# Hescock Subdivision

North Stonington, Connecticut

**REPORT**

ENVIRONMENTAL REVIEW TEAM REPORT  
ON  
THE HESCOCK SUBDIVISION  
NORTH STONINGTON, CONNECTICUT

PLAN SHOWING HESCOCK SUBDIVISION ON PROPERTY OF WILLIAM H. HESCOCK MYSTIC ROAD A.K.A. STATE ROAD #627 NORTH STONINGTON CONNECTICUT SCALES AS SHOWN JULY 1985

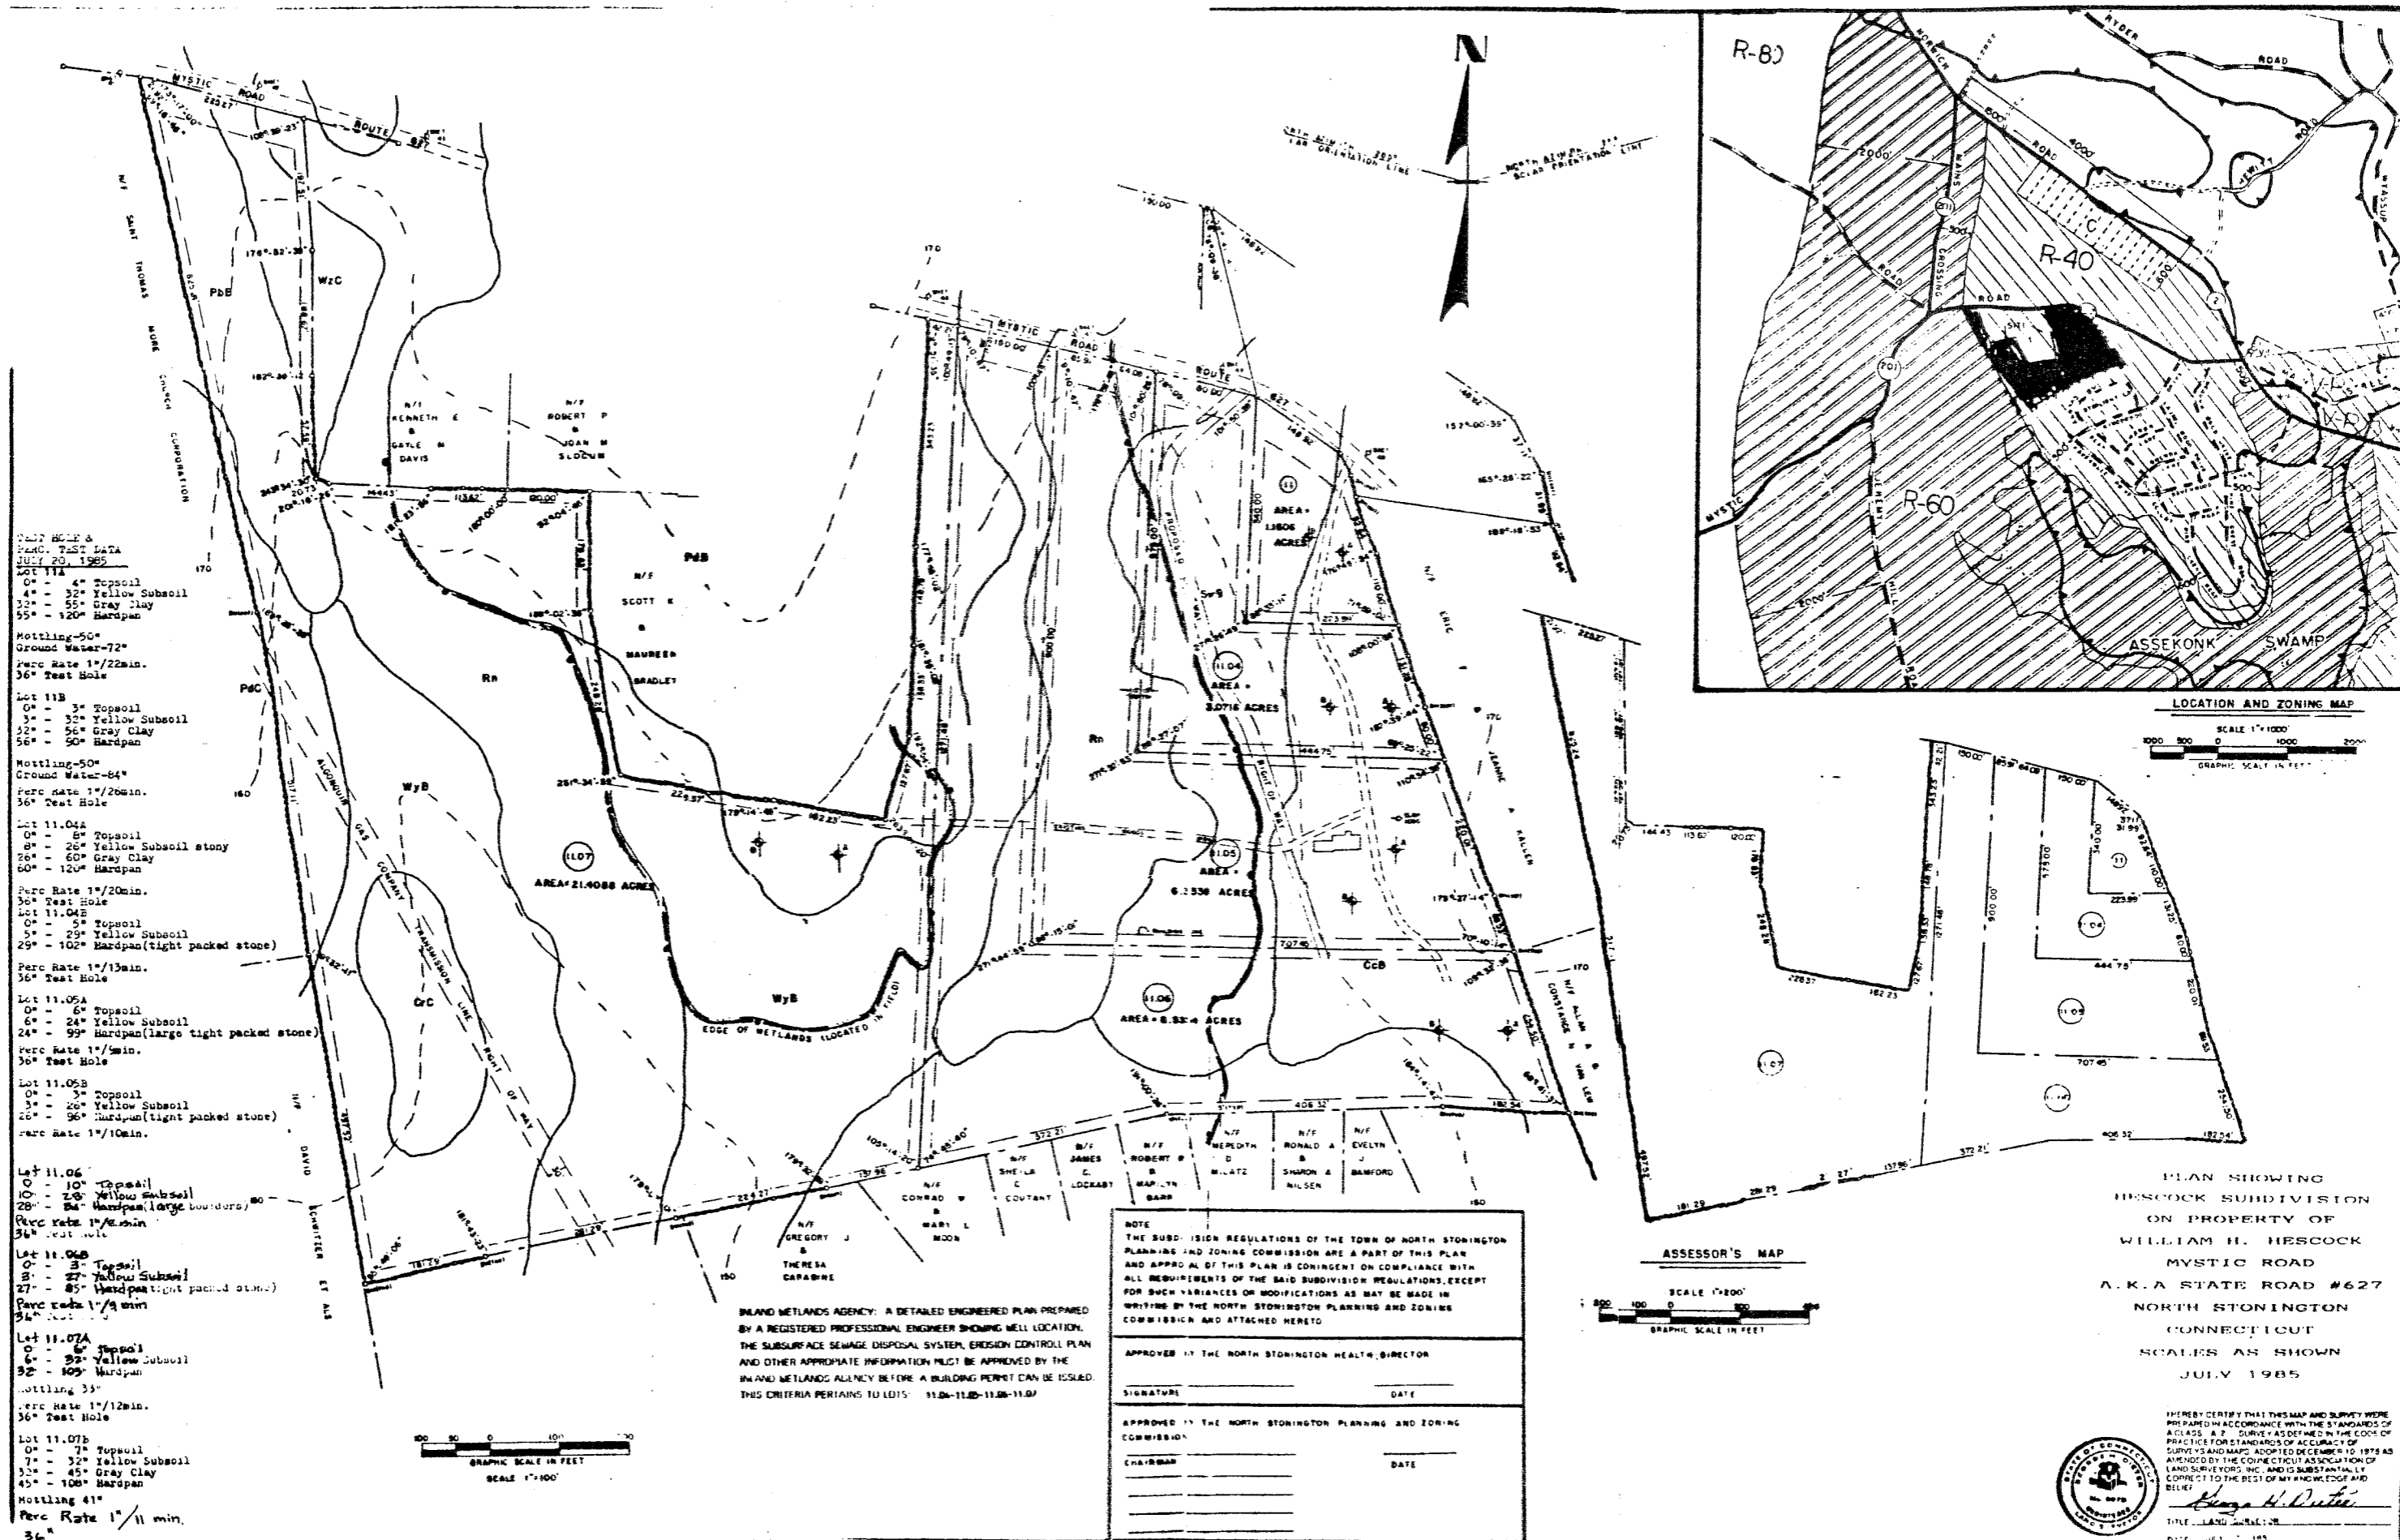
- It should be noted that most of the site has severe limitations for on-site sewage disposal.
- Details of proposals for drainage should be shown as plans indicate lots will be draining across others.

- Deep Test Pit interpretations seems to come to inconsistent conclusions, i.e., Lot 11A states mottling @ 50", gray clay @ 32", and groundwater @ 72". In wettest time of year, groundwater will be found @ 32" or less, and mottles will be found above the gray layer.

- If lots 11.05, 11.06, and 11.07 decide they want their own driveways in the future, there would be vast wetland disturbances which might preclude this possibility. Therefore, arrangements for the proposed driveway should be very carefully reviewed.

Based on the level of information and detail supplied by the applicant, it is difficult to assess the impact and efficacy of the proposed work. Soils mapping presented by the applicant was based solely on Soil Survey of New London County Connecticut, a publication of the U.S. Soil Conservation Service. While this booklet is a useful tool for planning, it lacks sufficient detail on which to base site-specific development decisions. Soils boundaries should be determined and staked in the field by a certified soil scientist. The boundary should also be shown on the applicant's site plans. Vegetation on the applicant's property indicates that wetland areas may be more extensive than indicated on the applicant's plans. It should be demonstrated by an engineer that upgrading the wetlands crossing will not result in ponding effects.

Furthermore, the site plans provided by the applicant are insufficient to show actual wetland encroachment. No details of the proposed improvement of the wetland crossing are provided. It is questionable that the site plan shows the exact extent of the entrance drive. Cross-sections of both the access drive and wetland crossing should be provided. The number, location and size of equalizer pipes for the wetland crossing should be specified. Finally, the applicant should specify the amount of fill to be placed in wetland areas.

The layout of the proposed subdivision meets the dimensional requirements of the Zoning and Subdivision Regulations, but does not appear to meet the spirit or general design intent of those regulations. In a conventional subdivision, lots would be laid out along existing or proposed roads with each lot having direct access to the road. The lots would be generally rectangular, with side boundaries perpendicular or radial to the road, as prescribed by Section 6.1 of the Subdivision Regulations. Excessively deep or irregularly-shaped lots would be avoided.
